Re: The Proposed Redevelopment of 125 Shaftesbury Avenue – Daylight and Sunlight

GIA have prepared this letter in order to address the various points raised within Bethany Cullen’s email of 14.03.17, which follows on from the third party daylight and sunlight review provided by Delva Patman Redler (“DPR”).

Figure 01 –VSC Cutback

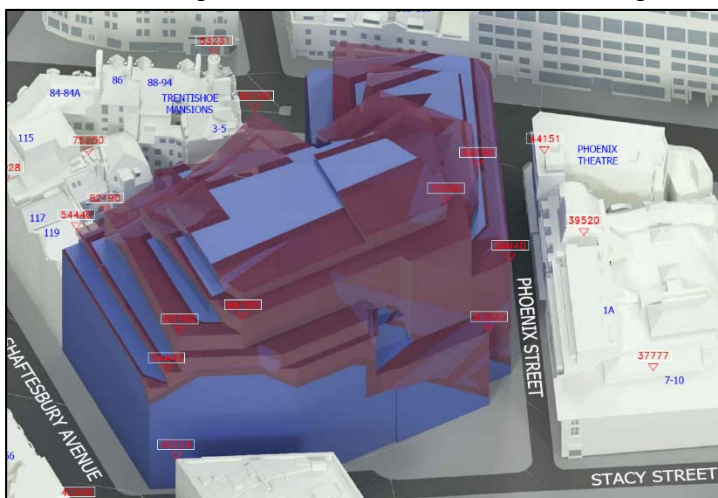
It has been suggested by DPR that small design alterations could potentially mitigate the daylight/sunlight impacts to 1A Phoenix Street.

Consequently, GIA have undertaken a technical cutback exercise in order to understand and illustrate the quantum of the proposed massing that would need to be conceded in order to demonstrate a BRE compliant position. The global cutback equates to c.36,000 sq.ft. GEA. It is assumed that some 30,000 sq.ft. would be attributable to 1A Phoenix Street. Given that the actual VSC change between existing and proposed is between 3%-4% VSC and the area loss to BRE compliance is c.30,000 Sqft, it is not considered that a modest change would have a less substantial impact to these four rooms, as is suggested by the DPR review.

The plot depicting this cutback can be found below in figure 01 (below) and in Appendix 01 of this letter.

Figure 02 –Mirror Massing (Green – Existing, Blue – Mirrored Baseline)

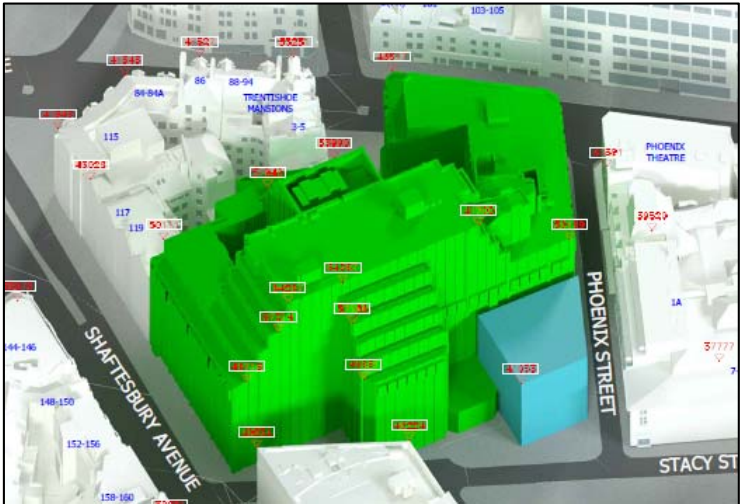
It is also acknowledged that the proposal extends onto the vacant portion of the site to the east. As suggested within Appendix F of the BRE Guidelines, GIA have run a further assessment on the site where we have hypothetically created a mirror massing of the 1A Phoenix Street development on this land. Appendix F.5 of the BRE Guidelines states:

The premise of this mirror massing exercise is to establish whether or not it is the height increase of the proposal or the infilling of the massing along Phoenix Street which is primarily causing the daylighting impact.

Our technical analysis illustrates that under these conditions, all four rooms detailed within Table 03 (below) would experience a de-minimis gain in light condition.

Figure 02 below visually depicts this baseline of this exercise, which can be seen more clearly in Appendix 03 and the results for which can be found in Appendix 04;
